WEST 19TH PLACE
TREMONT WEST DEVELOPMENT CORPORATION

PLAN AND PROFILE

TREMONT WEST DEVELOPMENT CORPORATION 14-00325-010 W. 19TH PL GREEN ALLEY DESIGN SERVICES CAD/25/08/14 00325-010 - 7/5/2017 3:23:13 PM

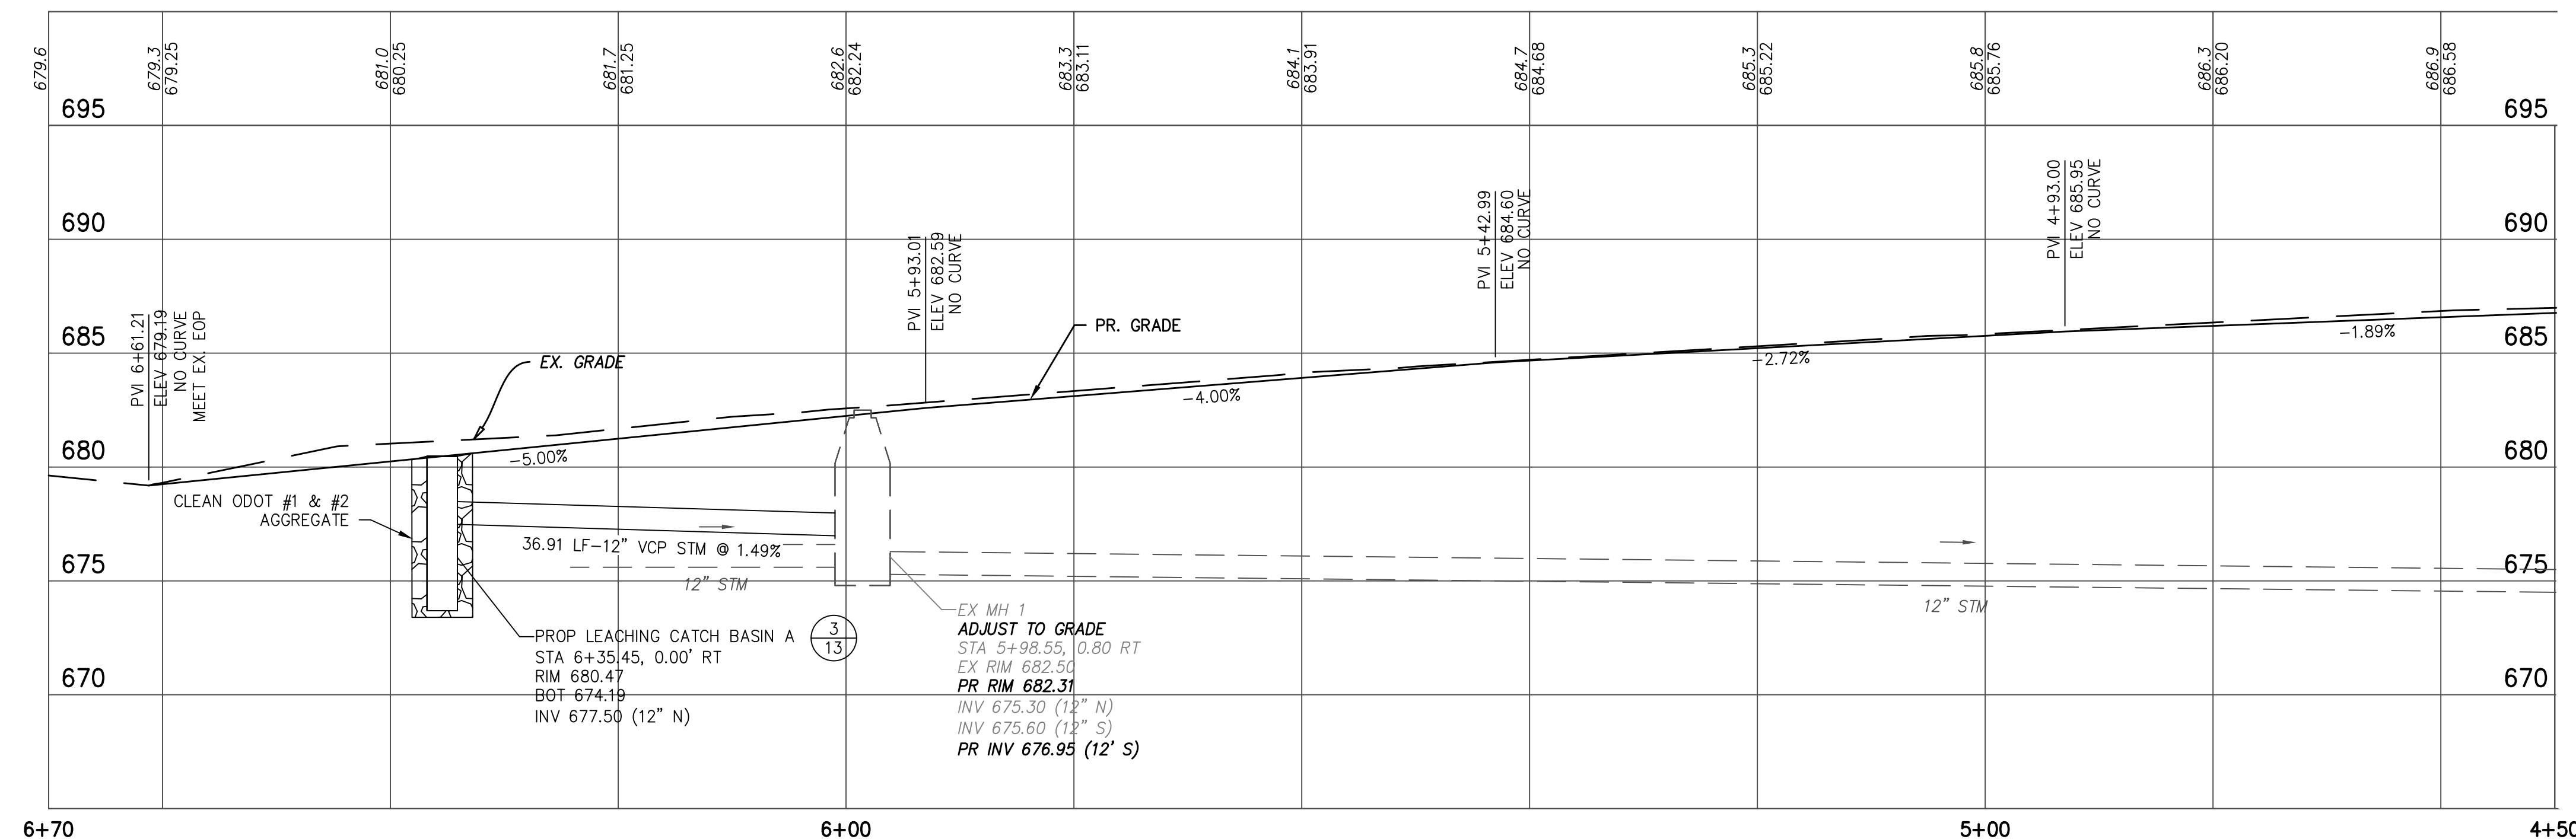
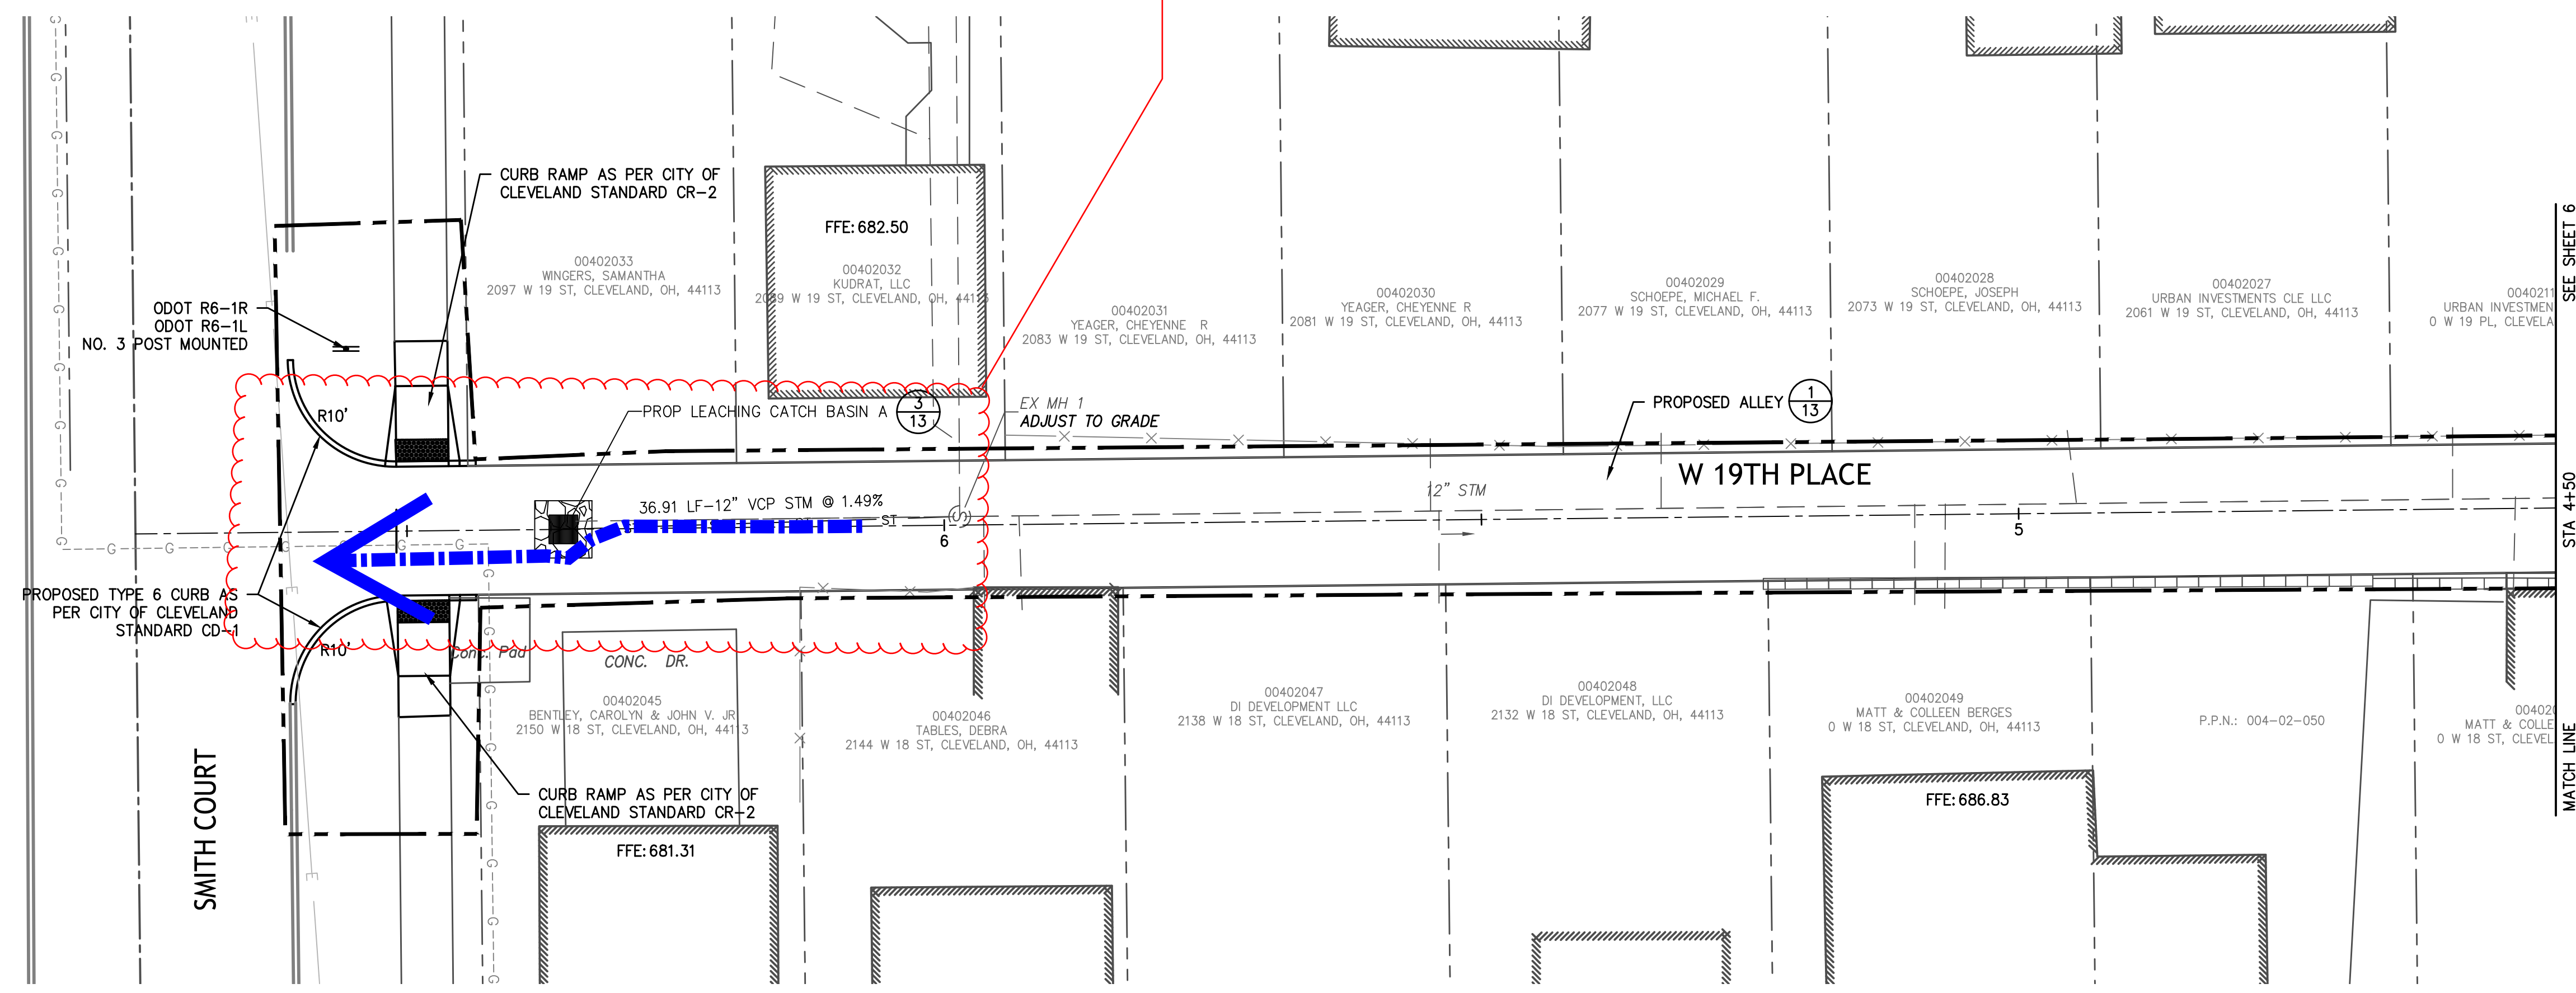
Vast majority of surface flow along center of alley bypasses the inlet as it reaches the inlet.

PLAN AND PROFILE

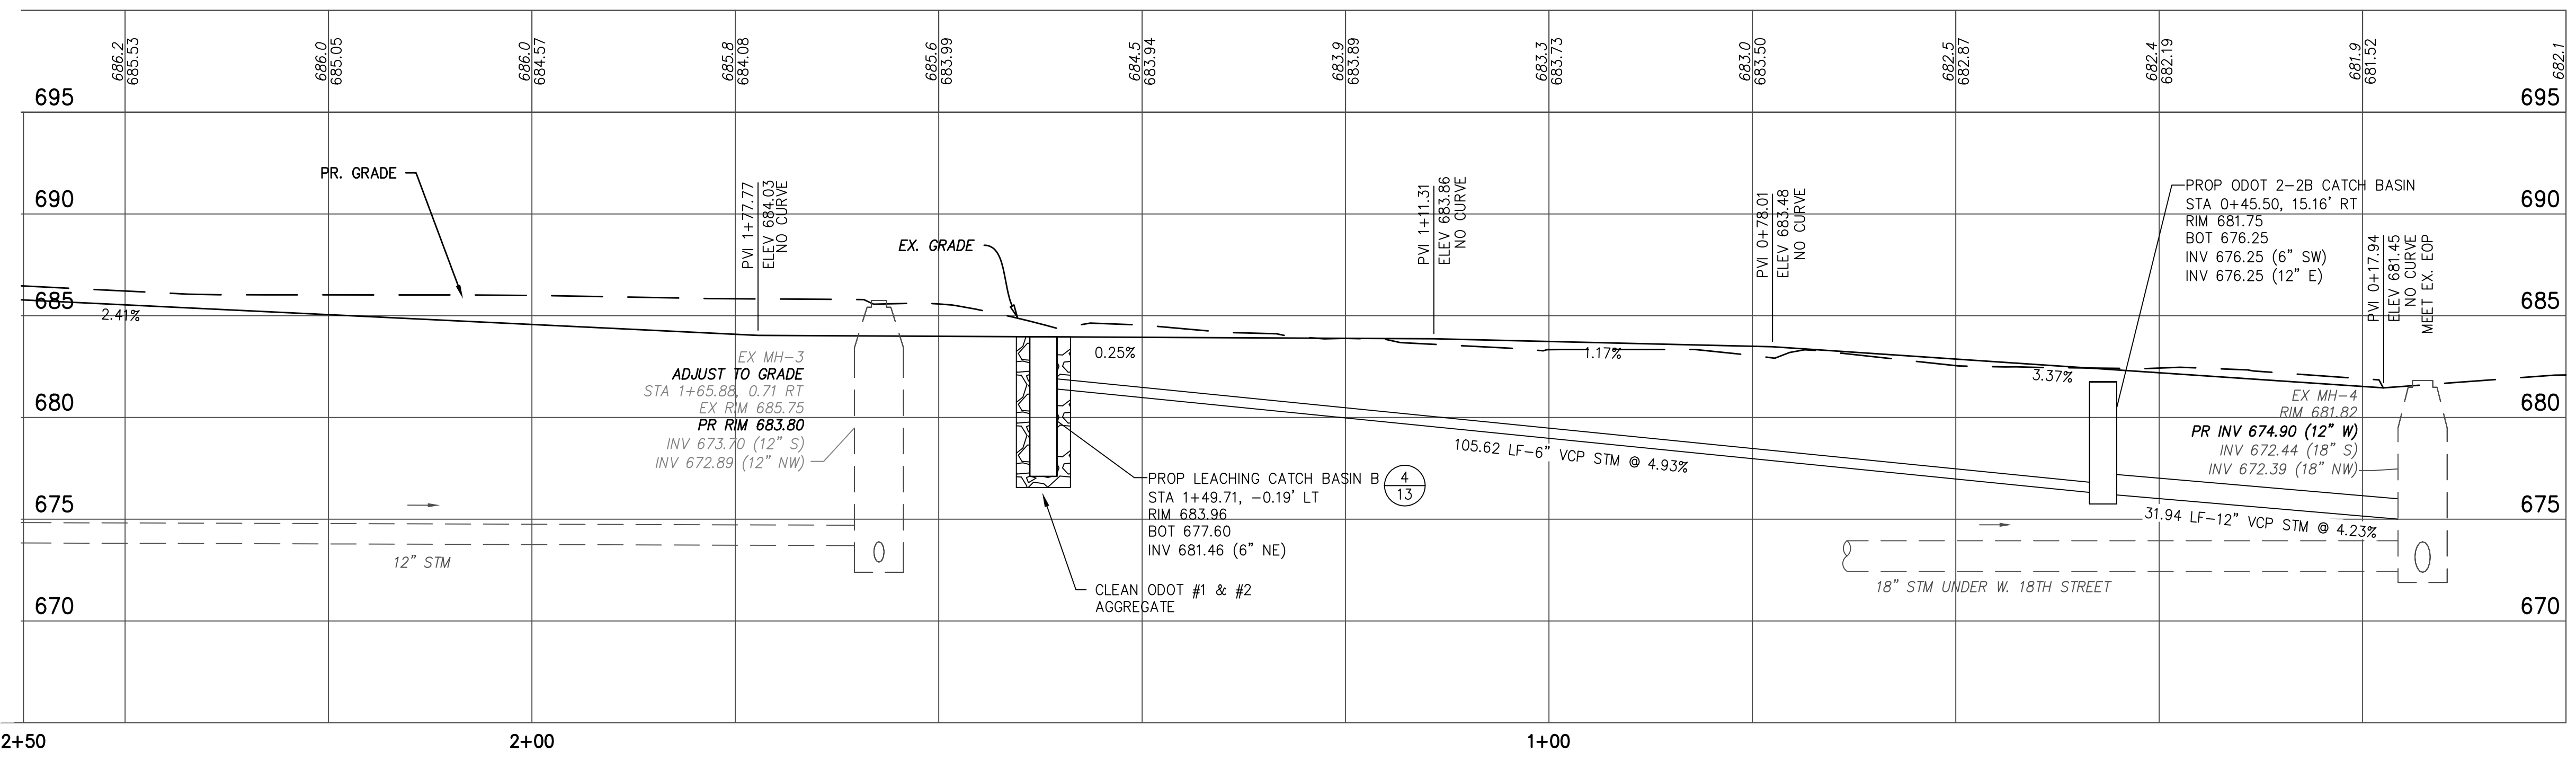
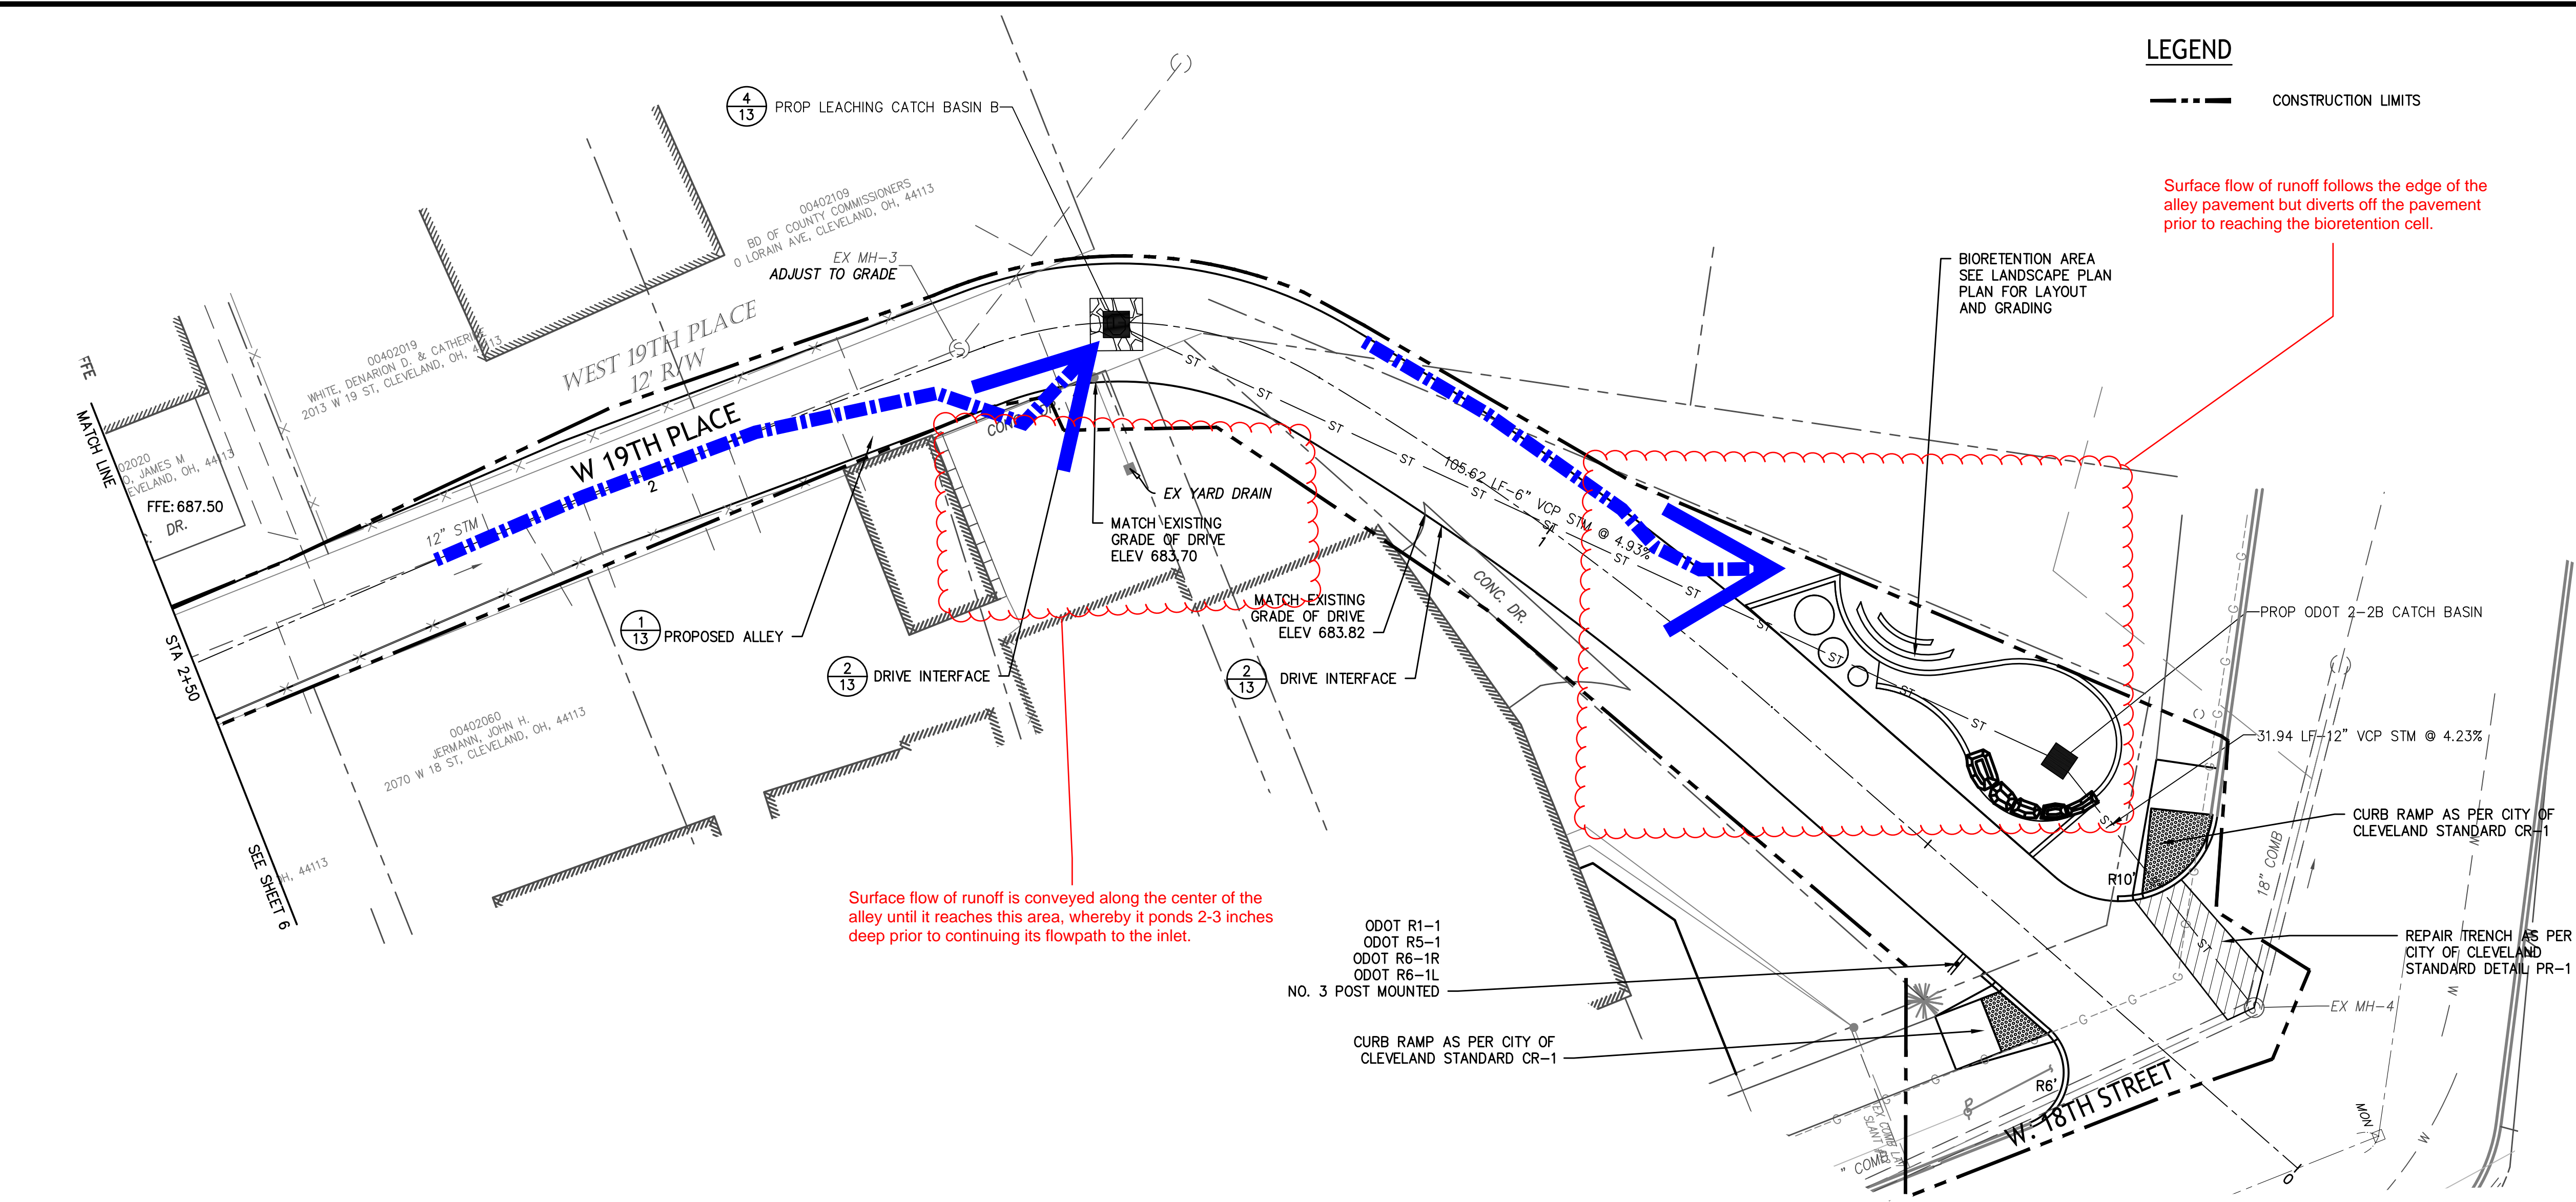
Surface flow of runoff follows the edge of the alley pavement but diverts off the pavement prior to reaching the bioretention cell.

Surface flow of runoff is conveyed along the center of the alley until it reaches this area, whereby it ponds 2-3 inches deep prior to continuing its flowpath to the inlet.
